**Appeal by: Bristol Airport Limited**

**Appeal Reference: APP/D0121/W/20/3259234**

**Proof of evidence of  
Tim Colles BEng (Hons)  
Transport**

Development of Bristol Airport to enable throughput  
of 12 million passengers per annum

Figure 4-1 Extract from C1124-SK-A38-010 Rev 11 showing access road to Lilac Cottages

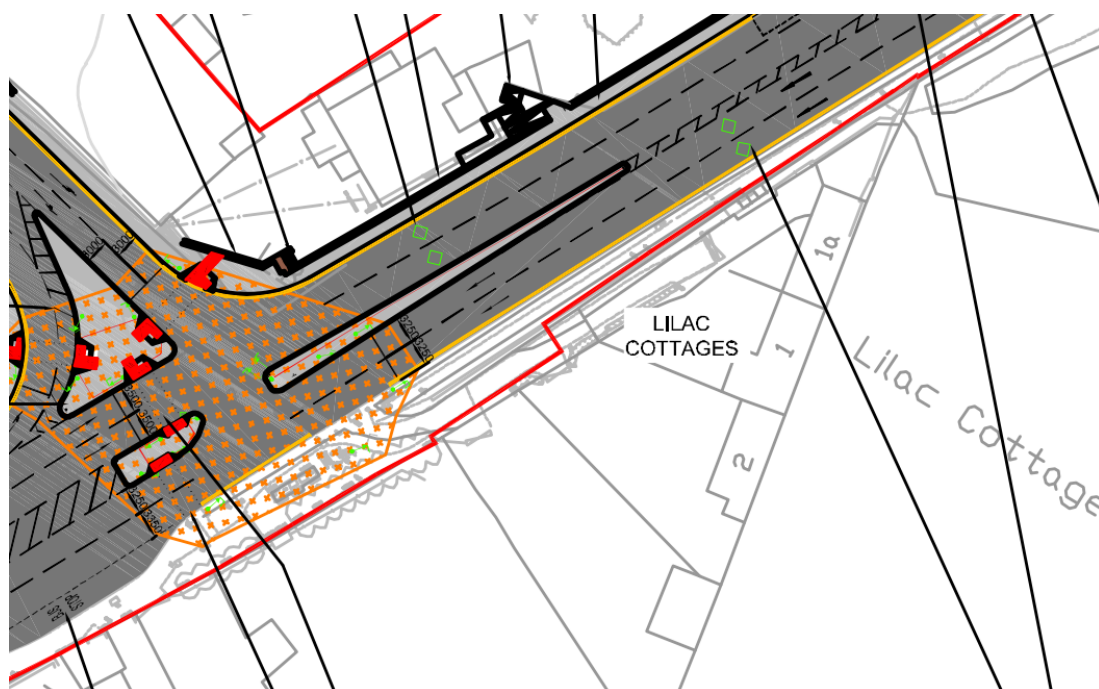
- 4.13.3. The access road to Lilac Cottages is located within the proposed junction improvement scheme. Access only appears to be possible from the A38 North, and egress to the to the A38 South. This manoeuvre appears to be very tight and there is no swept path analysis to demonstrate if this manoeuvre can be made. An extract of C1124-SK-A38-010 Rev 11 shows the proposed access to Lilac Cottages and is replicated in Figure 4-1.

**Figure 4-2 Extract from C1124-SK-A38-010 Rev 11 showing the A38 N merge**

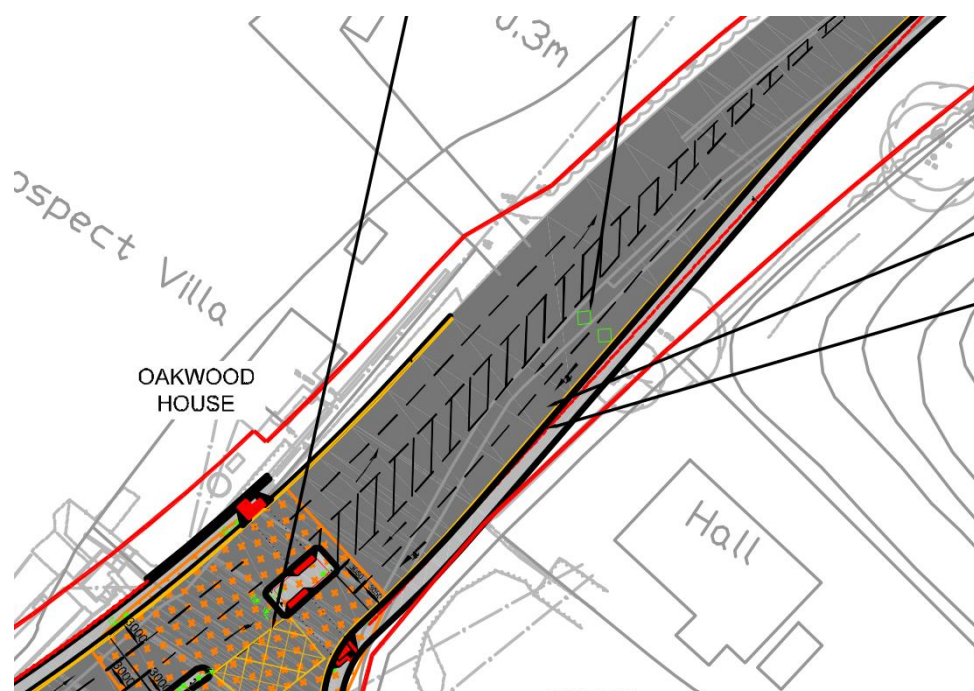
- 4.14.5. The merge length has been measured to be approximately 60m and therefore a third short than required and is therefore substandard. This would therefore either be unsafe or result in reduced junction capacity, both of which are contrary to NPPF paragraphs 102, 108 and 109 and policies CS10 and CS23 of the Core Strategy.

Figure 4-3 Extract from C1124-SK-A38-010 Rev 11 showing substandard splitter island

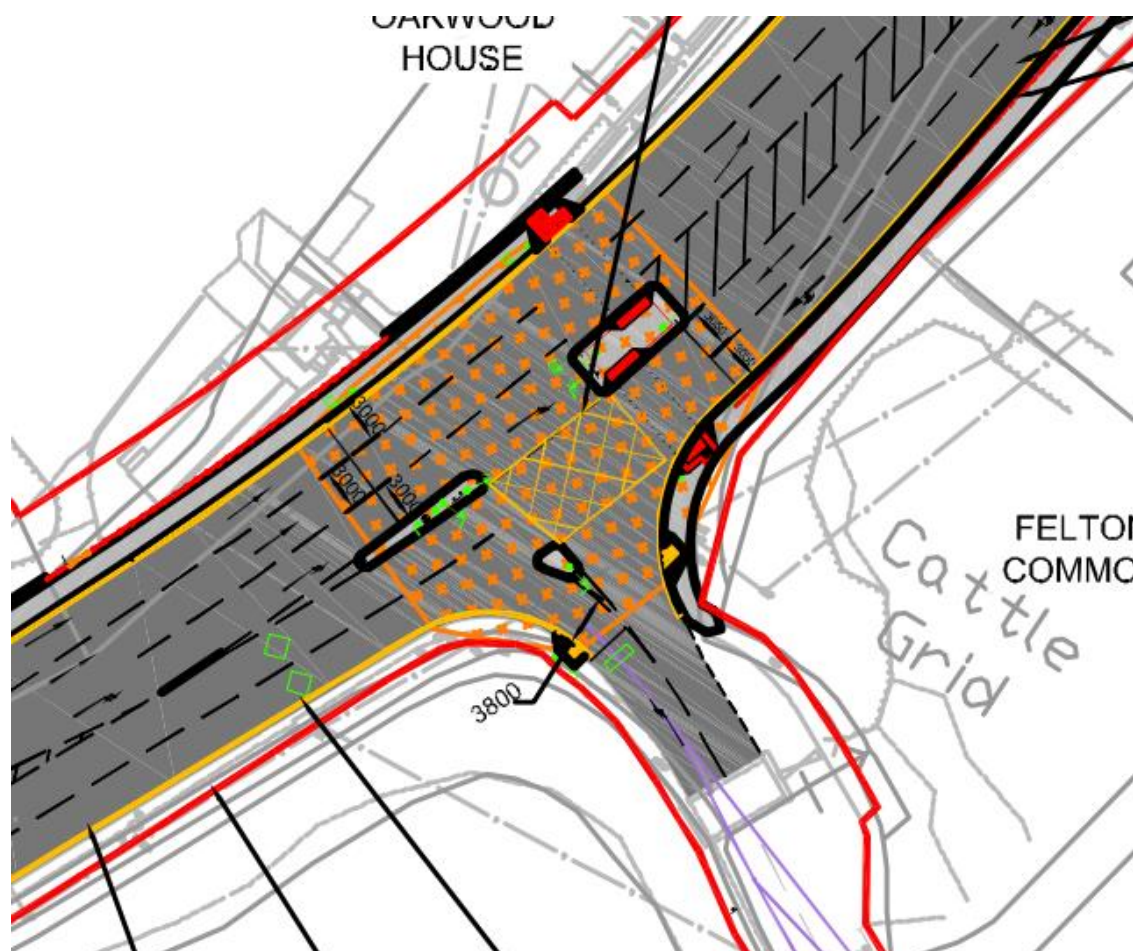
- 4.14.7. The splitter island in the centre of West Lane appears to be along the alignment of the A38 kerb line but is required to be set back by 1.5m to ensure vehicles don't collide with it. Setting the splitter island in the correct position will further reduce the area to accommodate the signal head resulting in the proposed scheme not being deliverable.

*'The nosing of central reserves and pedestrian refuges shall be set back a minimum distance of 1.5m from the edge of carriageway of the intersecting road.'*
- 4.14.9. It does not appear that the splitter island could be provided in the correct position and therefore the proposed scheme would not be deliverable. The splitter island location is shown in Figure 4-3.
